STATEMENT OF REASONS FOR APPEAL

RE Case No.: VTT-82838-SL (Related Case: ADM-2019-5444-SLD Address:
6021, 6025, 6029 East La Prada Planning Area: CEQA: ENV-2019-5445-CE)

Statement of Appeal
VTT-82838-SL

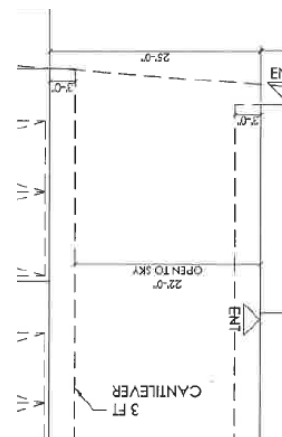
The Fire Lane Requirements are not met.

The 22 foot clear to the side road which runs between Lots 1-6 and 7-12. Is not actually 22 feet clear to the sky. See that the road width is 25 feet but the cantilever of 3 feet each is on both sides. So the clear to the sky portion is actually 19 feet. See at right.

Additionally, there is no space for an approved turning area as required. There is not enough space for a fire lane. Since, the width of private roadways for general access use and fire lanes shall **not be less than 20 feet**, and **the fire lane must be clear to the sky**. See below the applicant's design plans which do not provide a 20 foot fire lane clear to the sky.

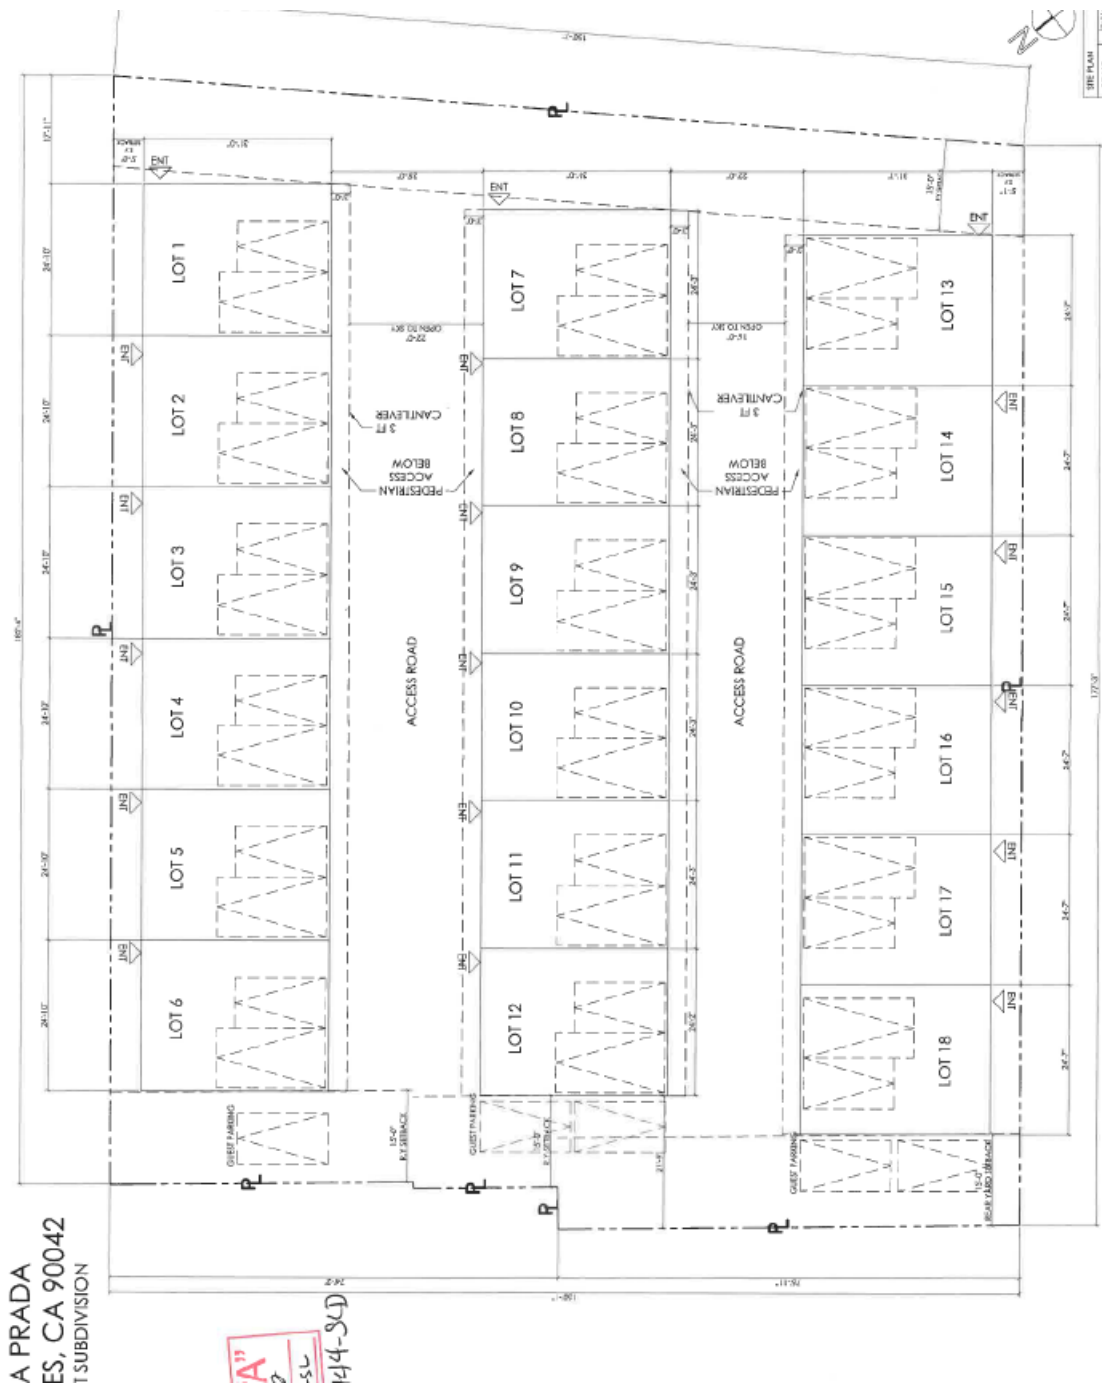
Units 6, 12 and 18 are more than 150 feet from the roadway - La Prada. The curb is 6 inches, the Parkway is 108 inches, and the sidewalk is 48 inches. See below.

The front setback at Units 1 through 6 is 17 feet 11 inches, each unit is 24 feet 10 inches.

6 inches + 9 feet + 4 feet + 149 feet + 17 feet 11 inches = 180 feet 5 inches including Unit 6. The front edge (entrance) of Unit 6 is 155 feet two inches from the street (roadway).

The front setback at Lots 13- 18 is 15 feet. Each unit is 24 feet 7 inches:

6 inches + 9 feet + 4 feet + 150 feet 6 inches + 15 feet = 179 feet 5 including Unit 6. This violates condition h.

The front edge (entrance) of Unit 18 is 154 feet 10 inches from the street (roadway). In violation of condition

The front setback at Units 7 through 12 is 15 feet, each unit is 24 feet 3 inches.

6 inches + 9 feet + 4 feet + 145.5 feet + 15 feet = 174 feet including Unit 12.

The front edge of Unit 6 is 150 feet nine inches from the street (roadway).

The diagram below from LA ZIMAS <http://zimas.lacity.org/mapsheet.aspx?val=157-5A229> Bureau of Engineering Cadastral Map with Contours (5 ft Intervals)

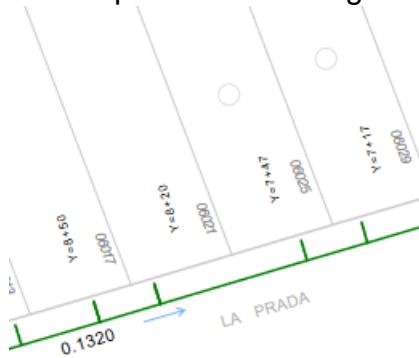
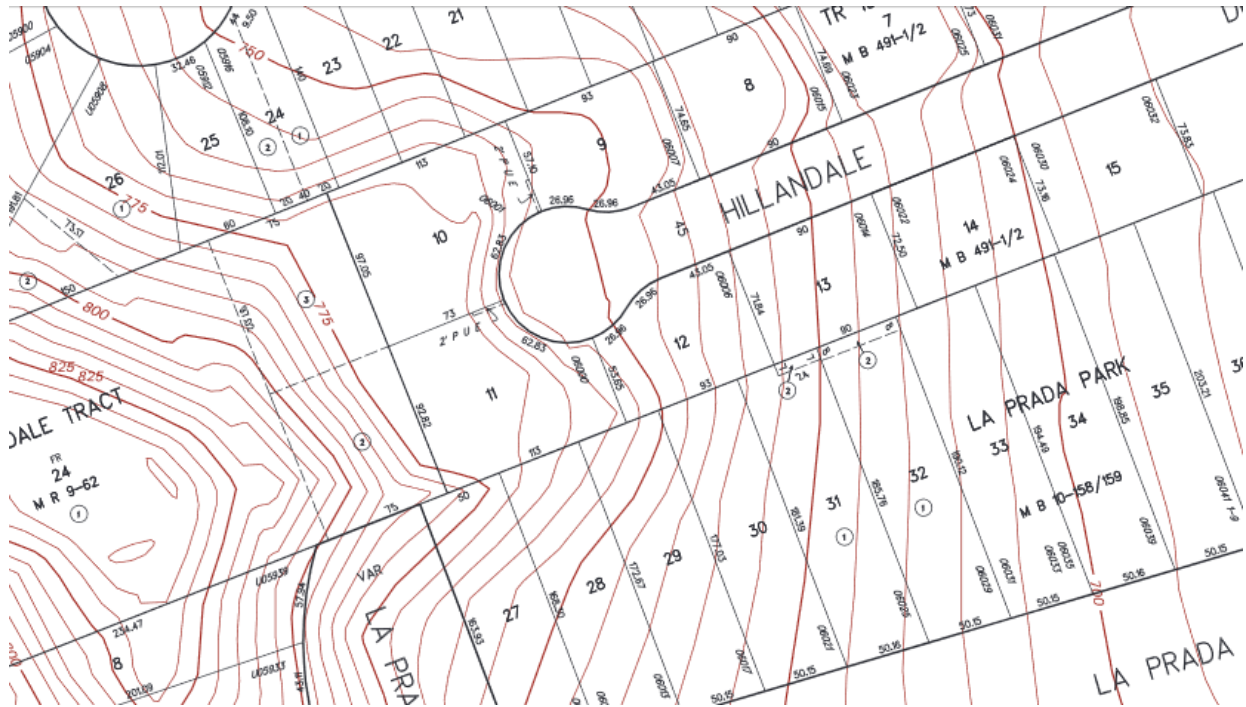
- The slope at the rear of the property is more extreme than that at the front it is:
 $\text{slope} = m = (750 - 715)/(150.45) = 23.3\% \pm .5\%$
- The slope at the front of the property is: $\text{slope} = (727.5-707)/150.45 = 13.6\% \pm .5\%$

The slope m from the highest to the lowest point is:

$$M = (750-707)/243.3 = 17.7 \%$$

The digital WYE map available at Navigatela.com at left confirms the approximate slope of 13.6 at the street near this project.

Therefore, the height is limited to 36 feet. Each of the small lots will be a one family dwelling. The new height at 41.7 feet still exceeds the height limit of 36 feet.

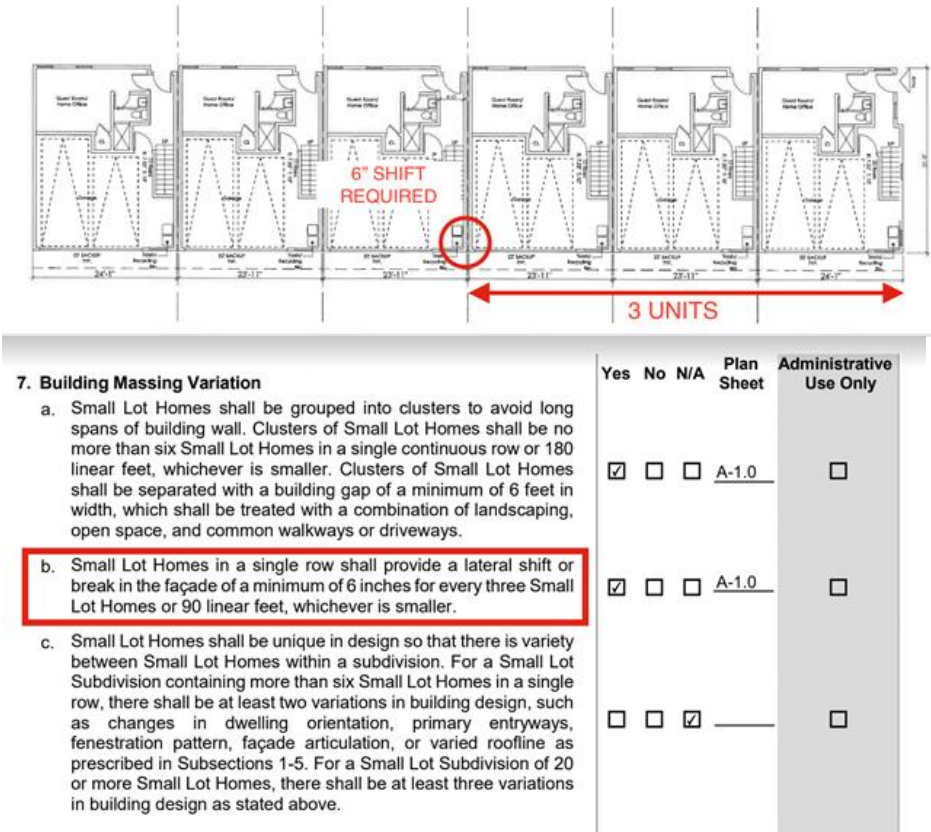
3. The applicant's measurements are inaccurate:

The length of the property per the City Clerk Land Records Map (Lot Cuts) shown below is 177.03 feet. In the applicant's drawings, a 15 foot front yard set back and a 15 foot rear yard set back is provided. The buildings measure 24 feet 7 inches each. This adds up to 177 feet 6 inches. $177'6'' > 177.03$, thus the applicant is using more land than is available.

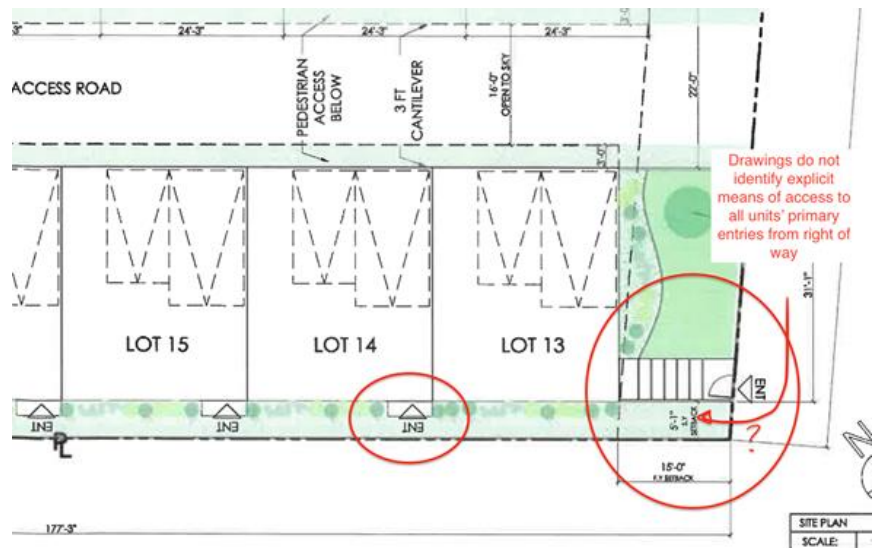
- Variation in Building Massing : This was an item outlined in the previous CID, and still has not been addressed.

- Pedestrian Access Primary Entrance of Units from Right of Way : The current plan does not show any explicit continuous 3'-0" wide pedestrian pathway from the public right of way to the primary entrance of the units that do not abut the street.

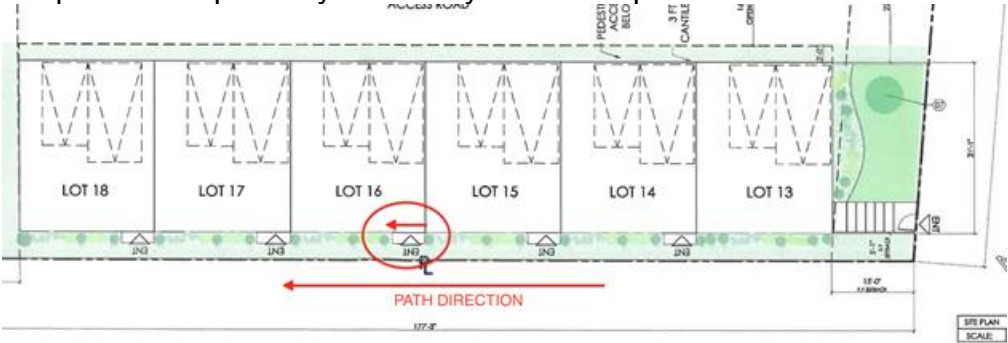
- Entrance Orientation : The small lot homes located in the interior of the subdivision shall orient primary entry toward ('orient toward' = perpendicular to) the pedestrian pathway. Currently shown as parallel

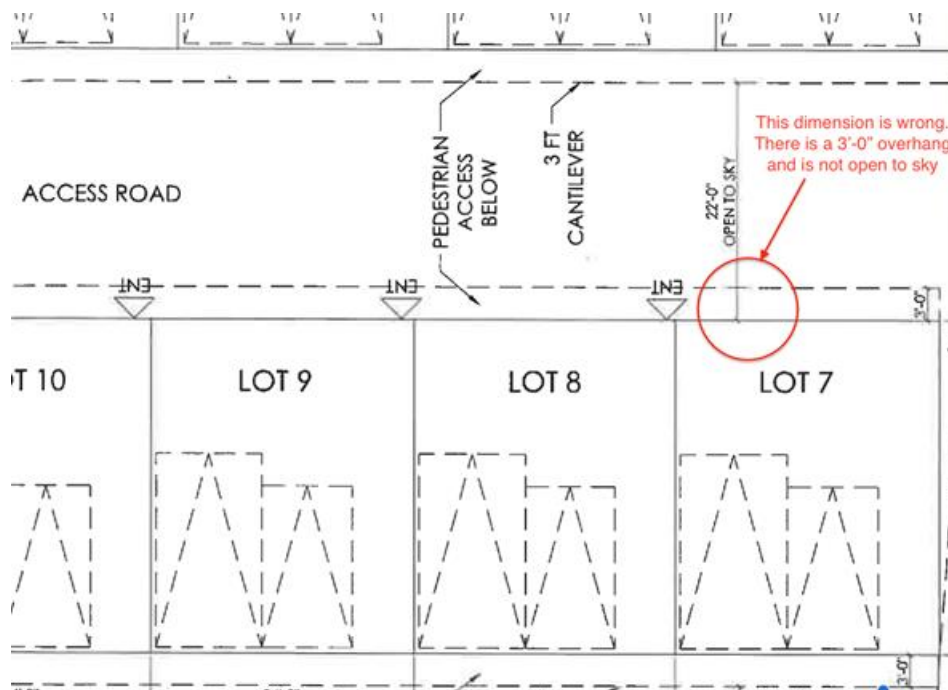
- Access Road : Given the current plans do not depict clear means of access to the furthest back unit (see pedestrian access item), it is unclear whether the 150'-0" max travel distance from the unit entry to the presumed fire lane (street) can be met.

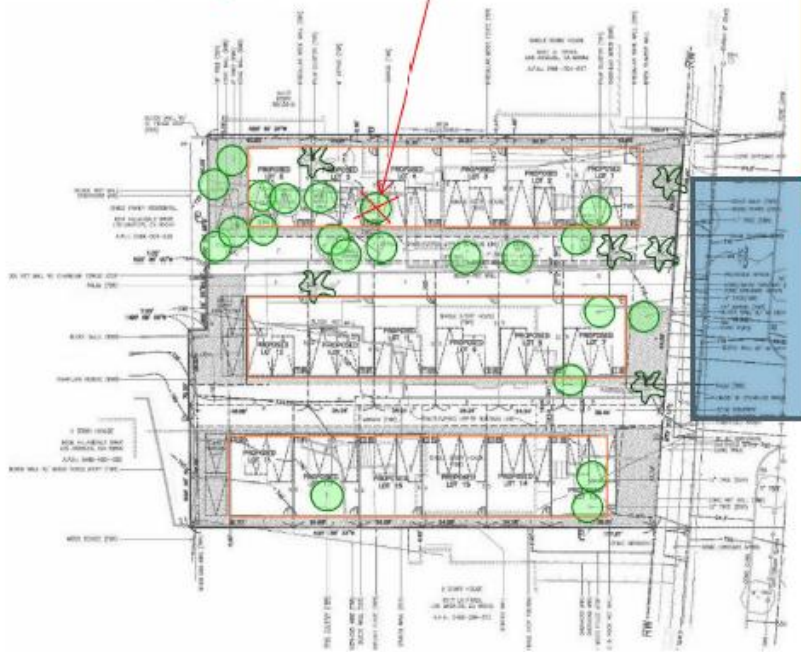
The diagram below highlights in green the number of trees that are to be removed from the project site per the proposed site plan. Without a proposed landscape plan, it is unclear whether the project's **required common open space** areas will meet the requirements outlined in the **Small Lots Design Standards**
